**MEETING AGENDA
SESSION OF THE PLANNING ADVISORY BOARD
CITY OF KISSIMMEE
CITY HALL, COMMISSION CHAMBERS
101 CHURCH STREET, KISSIMMEE, FLORIDA 34741-5054
WEDNESDAY, MARCH 19, 2025 AT 6:00 PM**

Public Hearing - Conditional Use with Site Plan to establish a drive-thru restaurant and retail establishments – 4307 W Vine St - CU-24-0014

**ADDRESS: 4307 W VINE ST
PERMIT NUMBER: CU-24-0014
PROJECT NAME: 4307 W VINE ST REDEVELOPMENT
REVIEW VERSION NUMBER: V.2**

TYPICAL TREE PROTECTION DETAIL

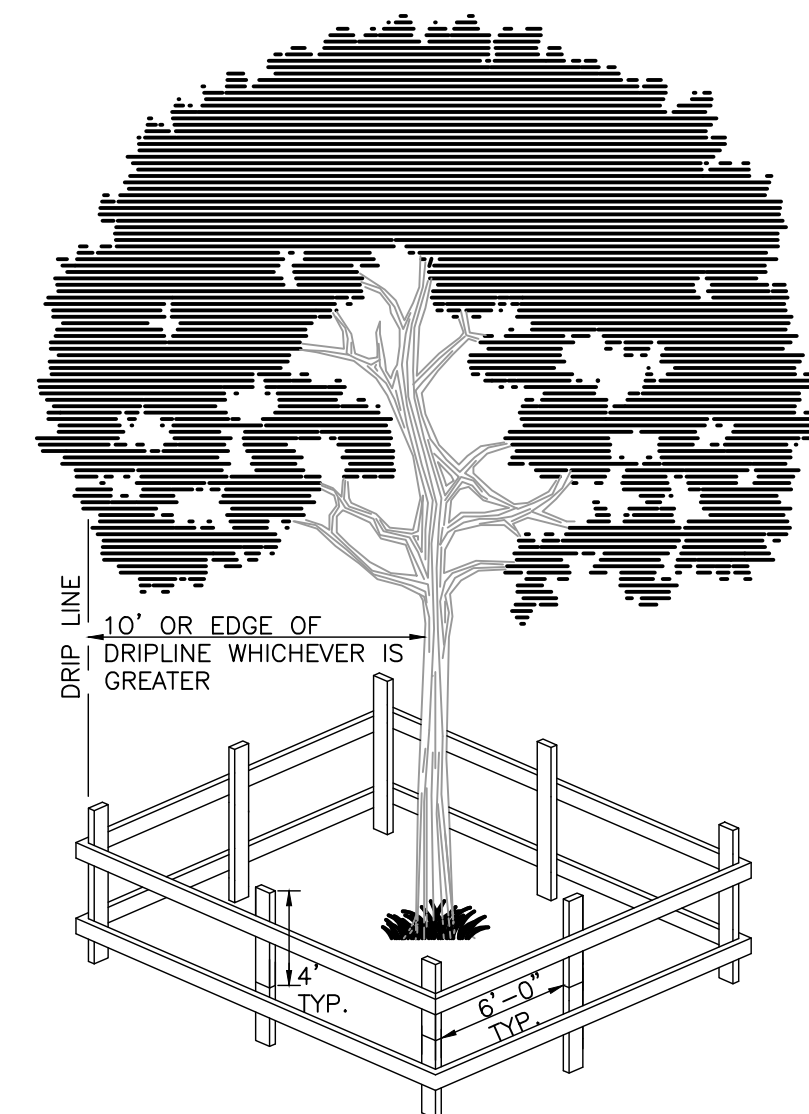
6. Please refer to Tree Protection Barricade Detail below:

Landscape Plan

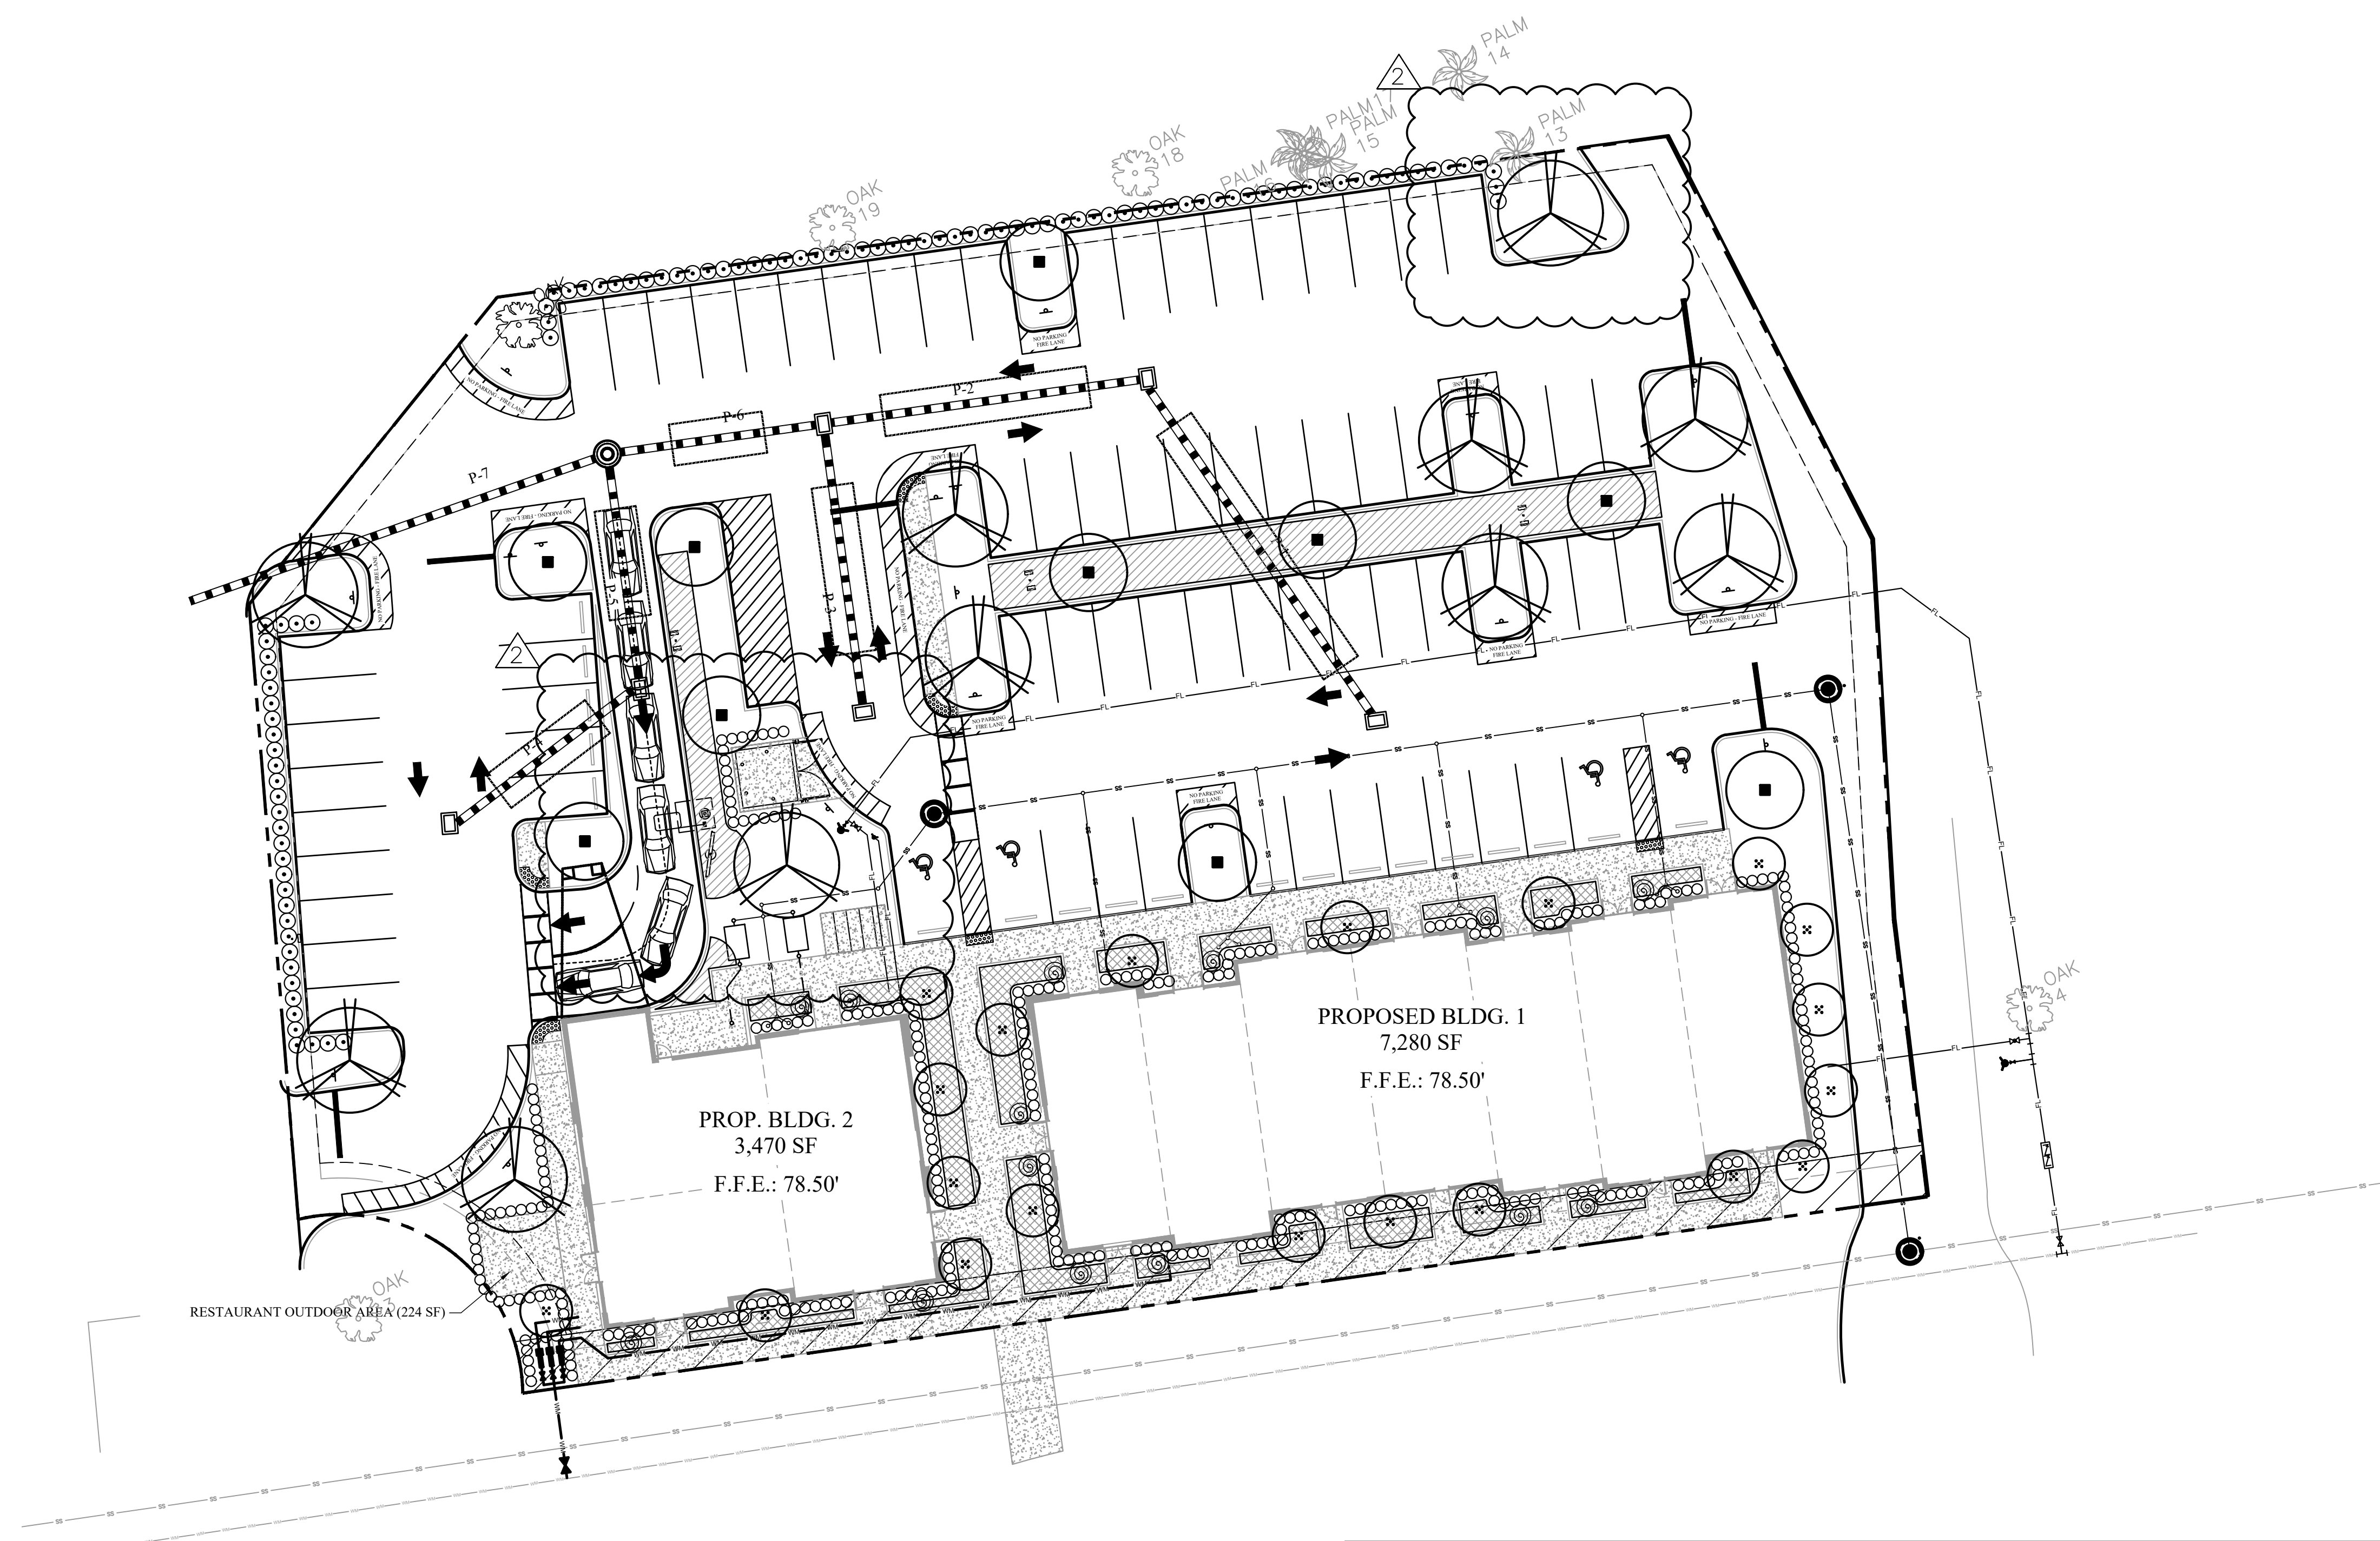
5. Please review LDC Section 14-8-23 Table 8-1 for the minimum separation requirements between landscaping and features and show them on the Landscape Plan. Table 8-1 shows those minimum separations. Please review the images below. Fire hydrants need to be 10 feet from trees and 5 from shrubs, 15 feet from alley edge of pavement, 5 feet from underground utilities, etc.

- Please show the 10-foot horizontal sight distance triangles at driveway intersection(s) with the street on the landscaping plans, in accordance with LDC §14-7-2(B) and §14-2, Figure 2-10.

- Verify the following separation is provided between landscaping and site features, in accordance with §14-8-23, Table 8-1:
 - Sidewalks, curb/gutters, bikeways, driveways: 3 feet for understory trees, 5 feet for canopy trees
